AMENDMENTS TO THE DRAWINGS

AMENDMENT UNDER 37 C.F.R. § 1.111

U.S. Application No. 10/650,193

Fig. 1D PRIOR ART

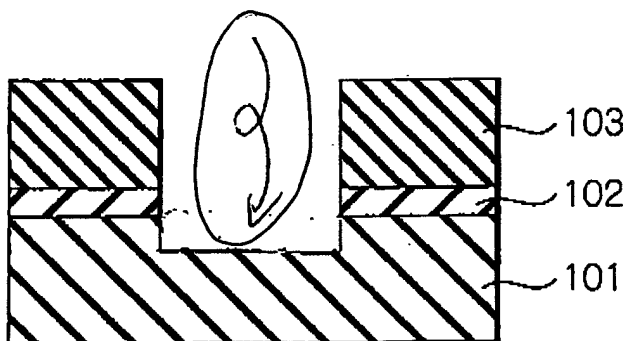
Please replace the drawing sheets numbered 2/87 and 21/87 with the concurrently attached replacement sheets. The annotated sheets indicate that Figs. 1D and 5D of the prior art are amended to each include a swirling arrow, which indicates that the etching stopper 102 is etched back by a dry etching process, followed by a wet stripping process performed upon the insulating interlayer 103 and the insulating interlayer 101, so that residues of the dry etching process are completely removed (see page 8, lines 7-11).
